Subject: Submittal Supporting Accelerated ABWR Review Schedule - **Closure of  
April 25, 1993 Meeting Issues**

To: J. N. Fox  
From: Carol E. Buchholz  
Subject: Closure of April 26, 1993 Meeting Issues

GE was requested to modify the containment sump protection discussion to indicate that the sump protection will be designed as described in Attachment 19ED of the SSAR. Enclosure 1 contains the markup of the SSAR which accommodates this request.

**Figure 19EE.4-1 IMPACT OF AEROSOL PLUGGING CREDIT ON OFFSITE RISK MEASURED BY WHOLE BODY DOSE AT 1/2 MILE AS PROBABILITY OF EXCEEDENCE**

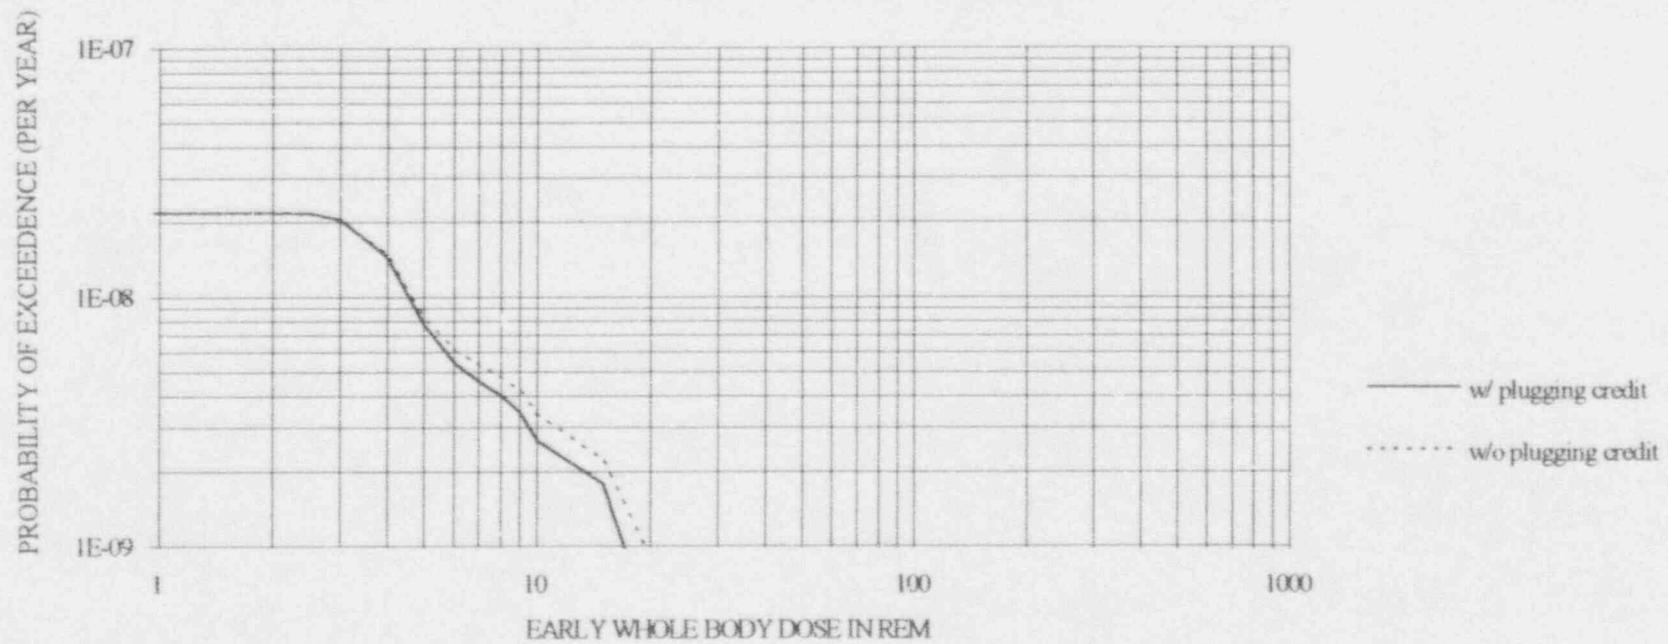
The impact of aerosol plugging on offsite risk can be assessed by eliminating the credit taken for plugging in the suppression pool bypass DET (Figure 19EE.2-1) and recalculating the source term release category frequencies in Figure 19D.5-3. The change in source term category frequencies is propagated into the consequence analysis as described in Subsection 19E.3. The results of eliminating the credit taken for aerosol plugging in the suppression pool bypass DET are listed below.

The impact of neglecting credit for aerosol plugging on offsite risk is presented in Figure 19EE.4-1. Probabilities of exceedence less than 1E-9 are considered insignificant in the consequence analysis. Divergences in the 1E-8 range are well within the level of confidence of the consequence study. Therefore, while aerosol plugging can significantly reduce the amount of fission products released from the containment given a bypass event, the phenomenological assumption has negligible impact on offsite risk.
